COUNCIL ASSESSMENT REPORT

Panel Reference	2017SSW037
DA Number	493/2016/DA-RA
LGA	Campbelltown
Proposed Development	Restoration of existing heritage-listed former CBC Bank building, demolition of existing commercial building at the rear of the site, construction of a 21 storey building at the rear of the site incorporating two levels of commercial tenancies and 101 residential apartments over 19 levels, and four levels of basement car parking
Street Address	Lots 1 and 2 SP 41598, 263 Queen Street, CAMPBELLTOWN
Applicant	Michael Brown Planning Strategies
Owner	Auchenflower Investments Pty Ltd
Date of DA lodgement	4 March 2016
Number of Submissions	26
Recommendation	Refusal
Regional Development Criteria	Development that has a capital investment value of more than \$20 million
List of all relevant s4.15 matters	<ul style="list-style-type: none"> • Heritage Act 1977 • State Environmental Planning Policy 65 – Design Quality of Residential Flat Development • Apartment Design Guide • Campbelltown (Urban Area) Local Environmental Plan 2002 • Draft Campbelltown Local Environmental Plan 2014 • Campbelltown Sustainable City Development Control Plan 2014

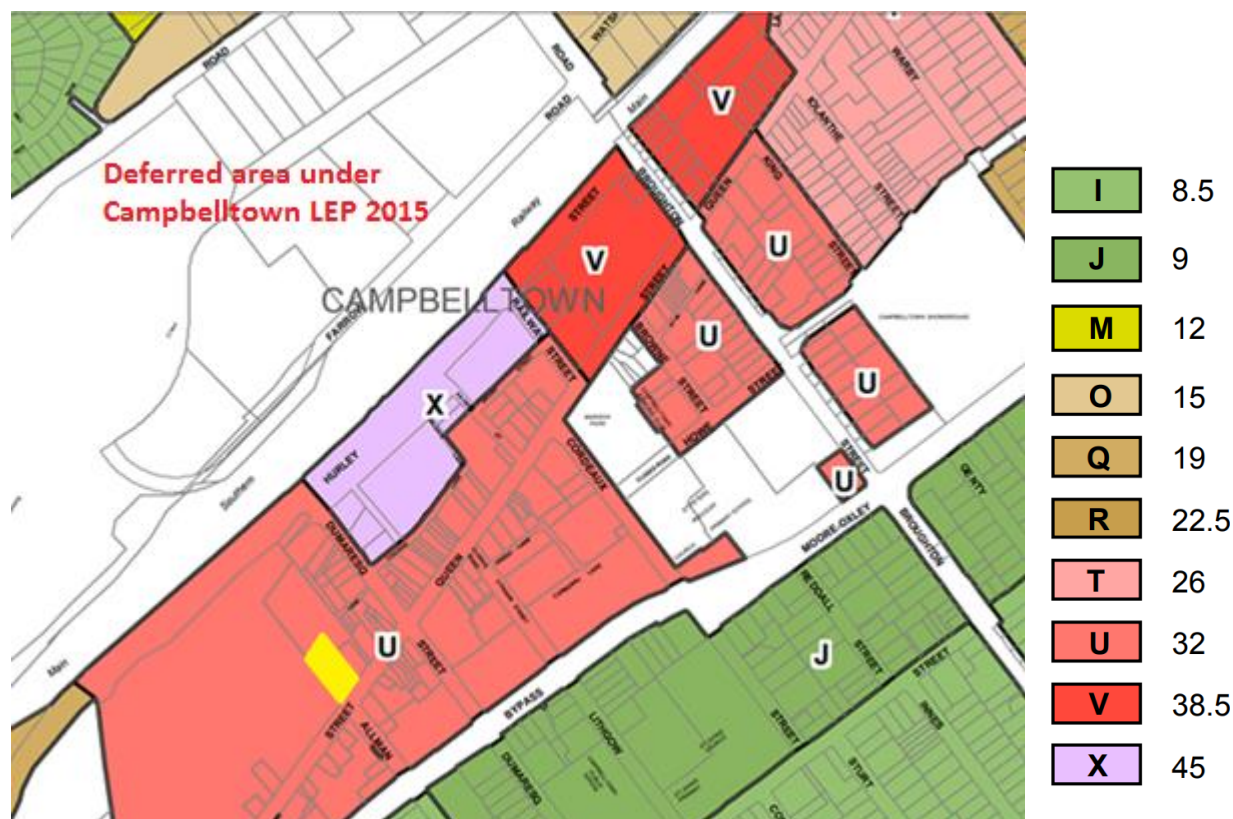
In response to the requirement that the development be in the public interest because it is consistent with the objectives of the particular standard and the zone objectives, the applicant provided the following information:

"It is considered that the public interest is better served as a consequence of the variation of the development standard of CLEP 2015 due to the constraints imposed by the heritage item on the property. Clearly the public interest is providing employment opportunities within the commercial component of the mixed use development and potentially in the hospitality industry for the growing population close to all amenities and services that are available in Campbelltown and more importantly conserving a significant state heritage item in the Campbelltown CBD and its adaptive reuse."

Council is not satisfied that the applicant's written request has adequately addressed the matters required to be demonstrated by subclause (3), and is not satisfied that the proposed development is in the public interest, because it is inconsistent with the objectives of the height standard. The height of the proposed development is not supported for the following reasons:
